PROPOSED CHANGES FOR BATHROOM

ASHGROVE KITCHENS

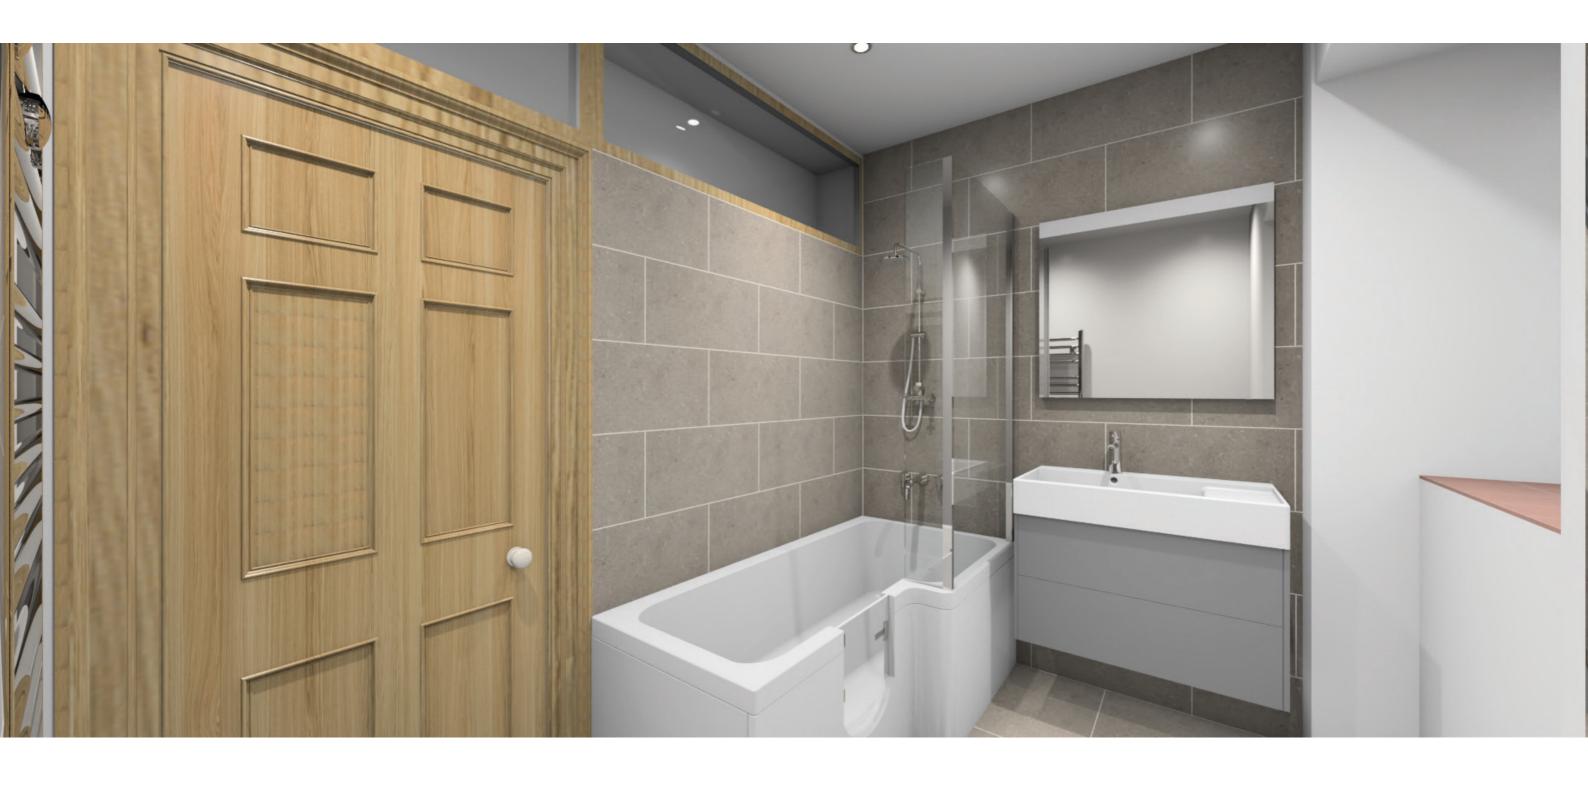
- Removal of Cabinetry Below Window Sill and Left open to allow for a wider space in front of the Sink Cabinetry Space required for ease of access.
- Original window & window sill to be retained with no planned modification.
- REDECORATING ROOM UPON COMPLETION
- Flooring to be changed to accomodate suite replacment matching tiles

PROPOSED CHANGES FOR BATHROOM

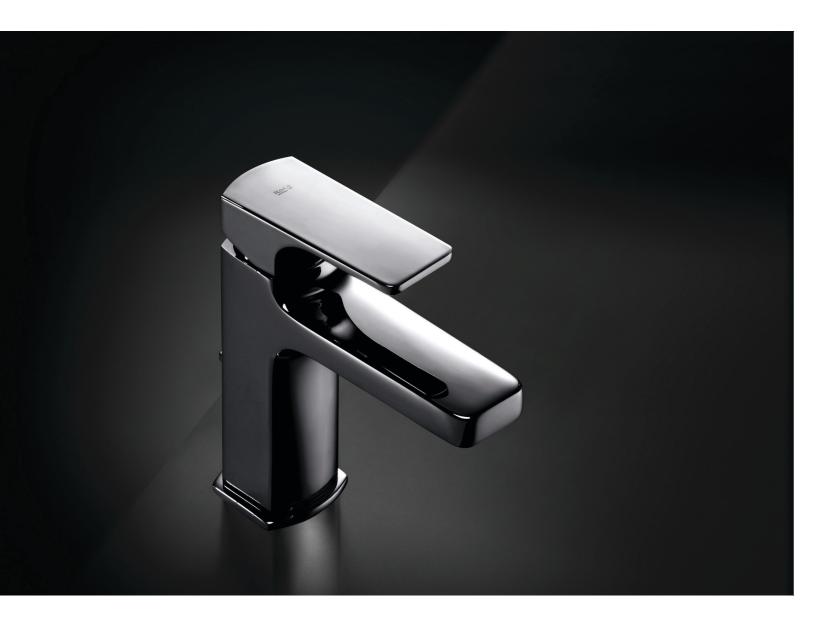
- Removal and replacement of bathroom suite with accessible bath and wall hanging cabinetry (see product listing below)
- Accessible bath with walk-in function
- REPLACMENT OF WALL TILING
- REDECORATING ROOM UPON COMPLETION
- Additional internal light window installed to match style of adacent window. Original window above the door to be reused/retained & adjacent window to be installed to the right hand side. (See plan view on next page)
- -Additional window installed in internal stud wall - This wall is not an original/supporting wall.
